CABINET MEMBER FOR ENVIRONMENT – 26 MAY 2020

EAST HANNEY – A338 – PROPOSED PUFFIN CROSSING

Report by Interim Director for Community Operations

Project title
East Hanney A338
Proposed
Puffin Crossing

Drawing No. 000000/IFC/1300/001 Revision 0

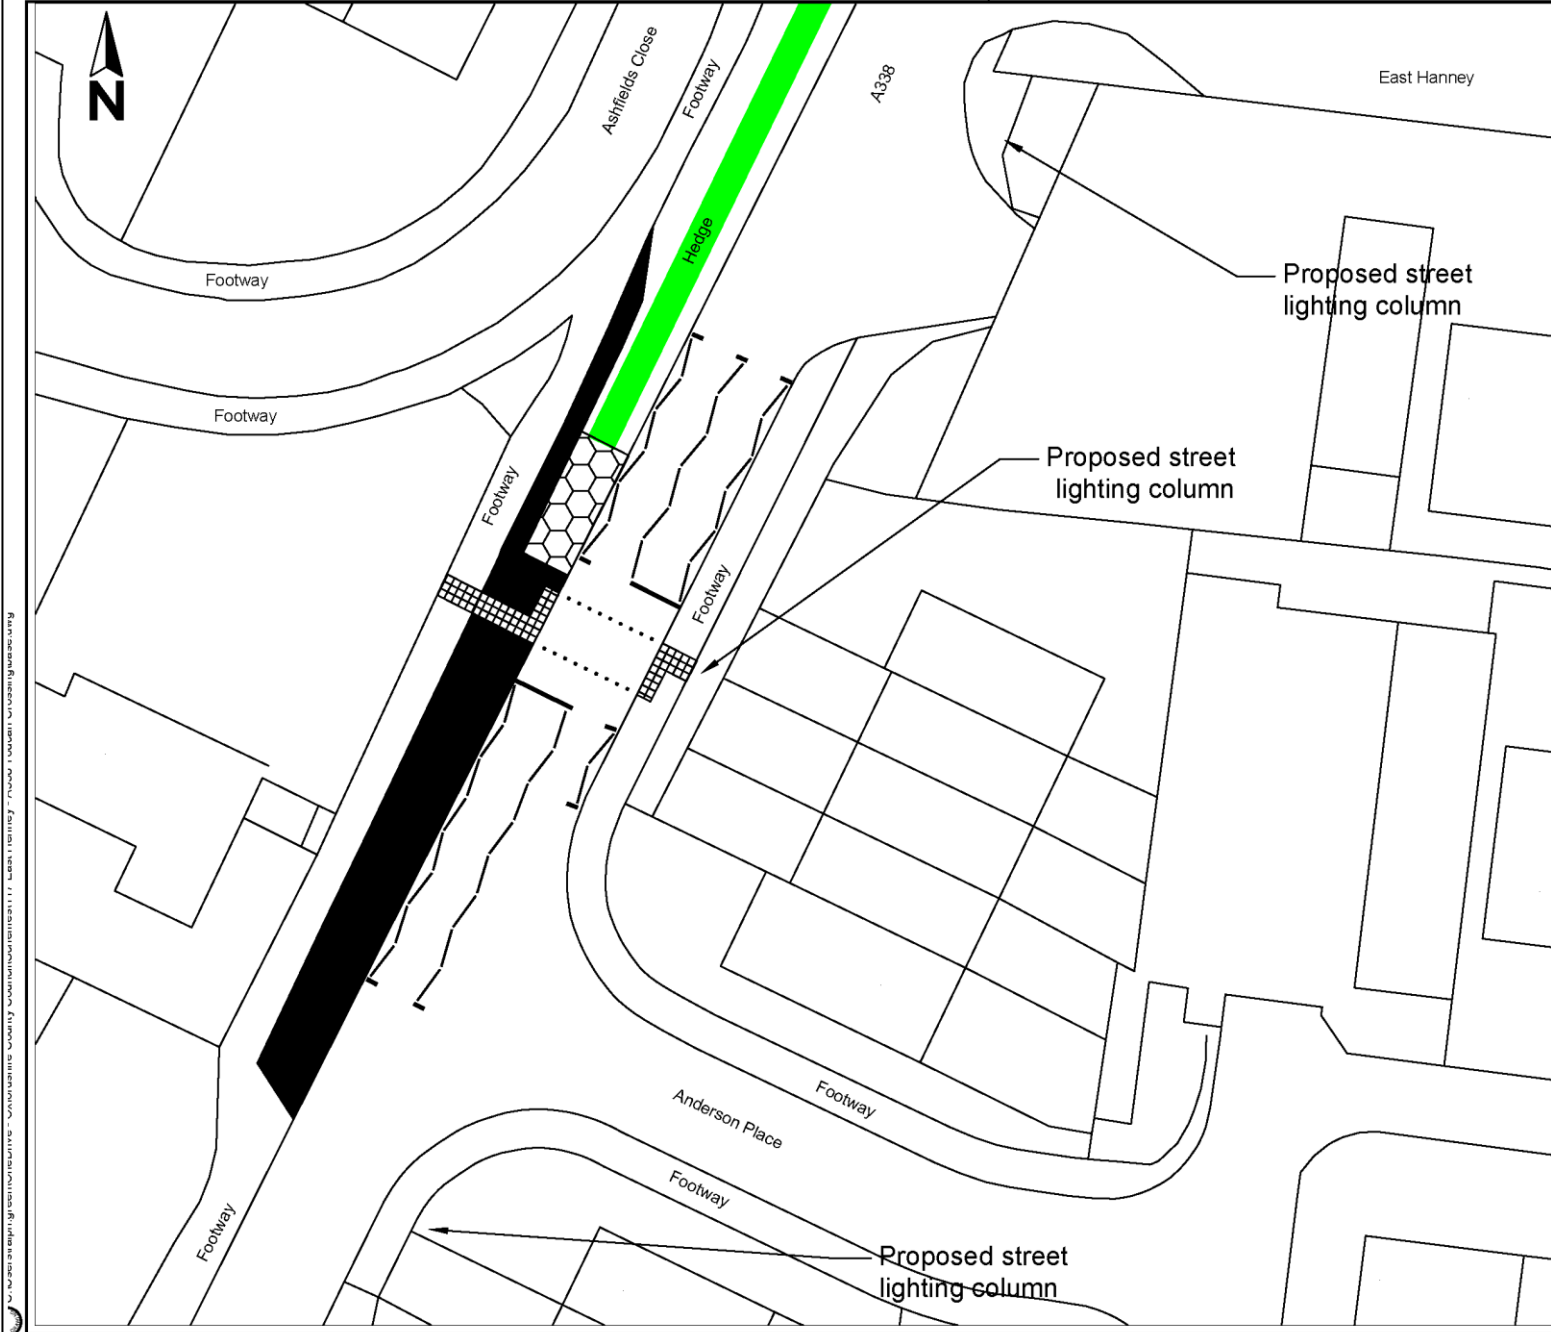
9. One objection was received from a local resident citing concerns that a signalled crossing would be less safe than an uncontrolled option, suggesting that children in particular who relied on the green pedestrian signal may be vulnerable if drivers failed to comply with a red signal. There were concerns over the proximity of side road junctions and potential increase in noise and air pollution from vehicles stopping then accelerating.

10. Expressions of support were received from fifteen parties including two local groups and thirteen members of the public.
11. Two supporters of the crossing queried (and a further actually objected to) the proposed footway widening with consequent grass verge and hedge loss to the north of the crossing and the forfeiture of its screening and noise reduction provision. There were also several concerns over the increase in lighting pollution.

(7) Local Resident, (Wantage)	<p>Support - I support the installation of a signalised crossing at this location, but I would like to raise an objection over the large area of verge that is shown on the map as being tarmaced over.</p> <p>East Hanney is a rural village and therefore large expanses of tarmac are out of place along what is currently a grass verge and hedge.</p> <p>Can the footway be widened only to a width that leaves a grass verge along the side of the road, as I also believe that without suitable prevention methods, such as wooden posts, the large area of tarmac will quickly be used as a car</p>

(15) Local Resident, (East Hanney)	<p>Support - I am generally in favour of a safer road crossing. I have minor concerns that the proposed site is not close enough to the bus stops and people will still cross the road further north, close to Ashfields Lane.</p> <p>I am also unclear as to the purpose of the proposed "hard standing". Is it to be incorporated into the widening of the footpath or is it for another purpose? As shown on the plan it looks like a car parking space and that would be wholly inappropriate.</p> <p>I would hope that the proposed lighting would be as discrete as possible and at as low an intensity as possible so as not to affect the nearby houses or the generally unlit nature of the village.</p>

12. The hedge removal will be required to meet visibility standards, especially critical with the open nature of the site and high prevailing vehicle speeds. The lighting improvements are also required to meet design standards although the design will be as sensitive as possible.
